**TENDER FOR**  
**RUSSELL TOWNSHIP RECREATION COMPLEX PARK PROJECT**

**ADDENDUM #1**

June 14<sup>th</sup>, 2021

## CULVERT CROSSING

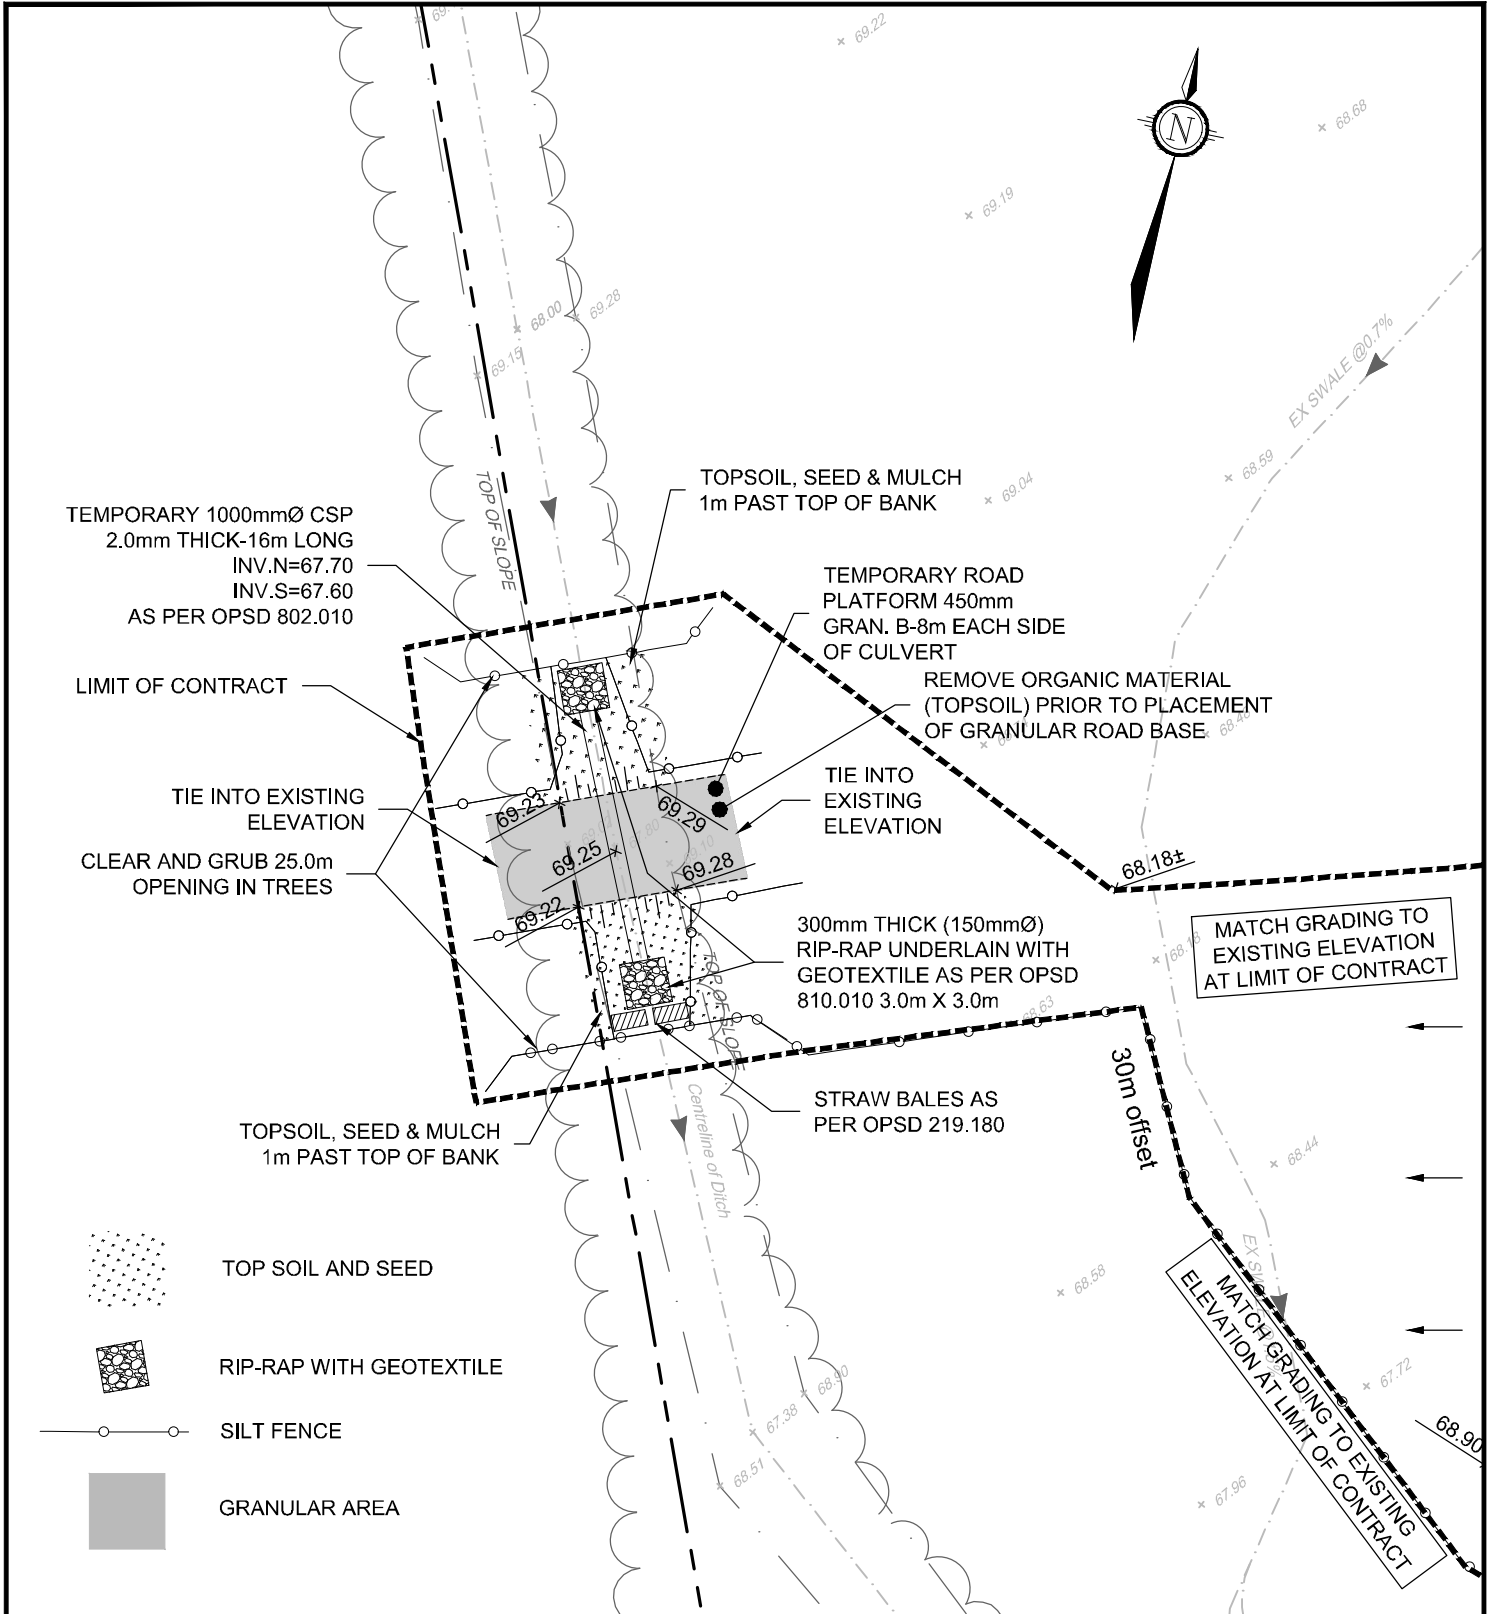
- The installation of a culvert and associated grading at the north west corner of the site has been added to the project. Refer to the Culvert Crossing Detail (CSK1) for further information.
- The pavement structure composition provided on the Grading and Servicing Plan (121029-GS) has been revised to reflect recent geotechnical recommendations. The pavement structure for the parking area (light duty) should be revised with the following:
  - 40mm HL3 (PG-58-34)
  - 50mm HL8 (PG-58-34)
  - 150mm Granular A
  - 300mm Granular B Type II
